PLAN CORRECTIONS REPORT 000028-2020-APP FOR CITY OF OAKLAND PARK

APPLICATION DATE: 01/15/2020 **SQUARE FEET:** 0.00 **DESCRIPTION:** 670 E Oakland Park Blvd - Ram Development Multi Use
EXPIRATION DATE: **VALUATION:** \$0.00 separate commercial and residential

subject: RAM Development Traffic Review

Traffic Impact Study

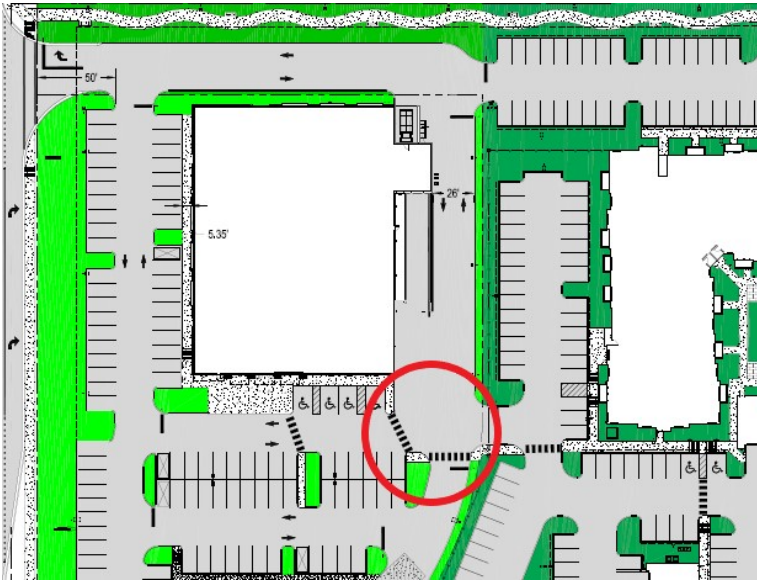
1. Please include the 2019 peak season correction factor report in Appendix B instead of the 2018 table. The PSCF is still 1.03 for the dates when traffic data collection therefore an update to the intersection volume worksheet and traffic analysis is not necessary.
2. Please update the southbound left turn volume at the NE 6th Avenue and NE 26th Street (PM Conditions) in Intersection Volume Worksheet Table B-2. The table has 11 vehicles but the raw traffic counts sheet from Traffic Survey Specialists and Figure 3 indicates 112 vehicles. Please update the traffic analysis if necessary.
3. Please update the ingress and egress trips for ITE Code 933. The PM peak hour ingress trips should be 35 and the egress peak hour trips should be 36.

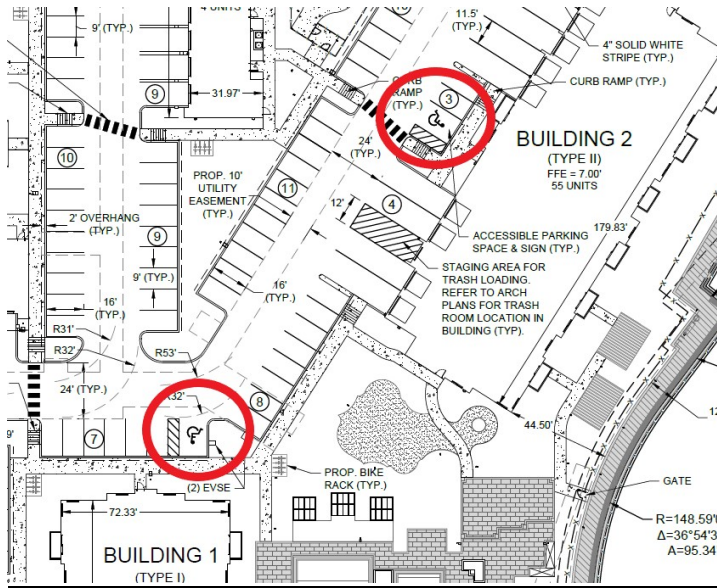
12. Please provide a copy of the AutoTURN simulation for each of the proposed site access ingress and egress driveways. Please also include an AutoTURN simulation for the westbound left U-turn movement at the NE 6th Avenue and Oakland Park Boulevard signalized intersection.
13. Please provide a copy of the approval of the NVAL line amendment.
14. Please ensure that the handicap parking spaces are oriented appropriately on all plan sheets per the handicap parking space details and criteria.
